Figure 2 - Rework of Hydraulic Power and Control Unit

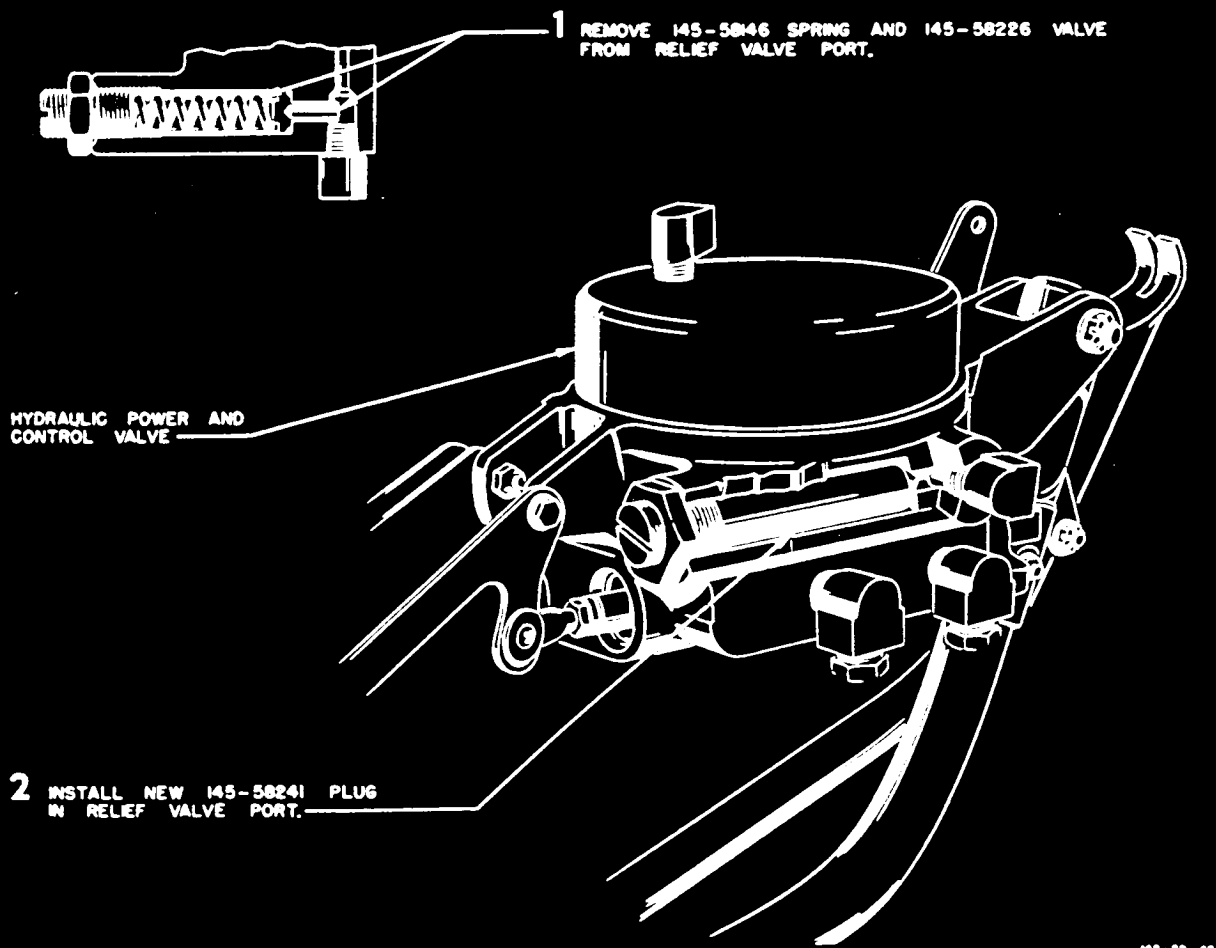
7. Install the 145-58803-24 line assembly from the relief valve to the regulator.

8. Install the 145-58803-26 line assembly from the relief valve to the tee on the side of the reservoir.

9. Remove the 145-51031-30 sump assembly from the union on the hydraulic pressure line just aft of the firewall. Install the 145-38801-58 line from the hydraulic regulator to the union.

10. Remove the coverplate on the hydraulic pump drive at right-hand side of engine accessory section, and install 145-58189 adapter, hydraulic pump, and lines.

11. Connect the hydraulic pump pressure hose to the lower fitting on the new relief valve.

12. Connect the hydraulic pump suction hose to the lower fitting on the regulator.

See Figure 2
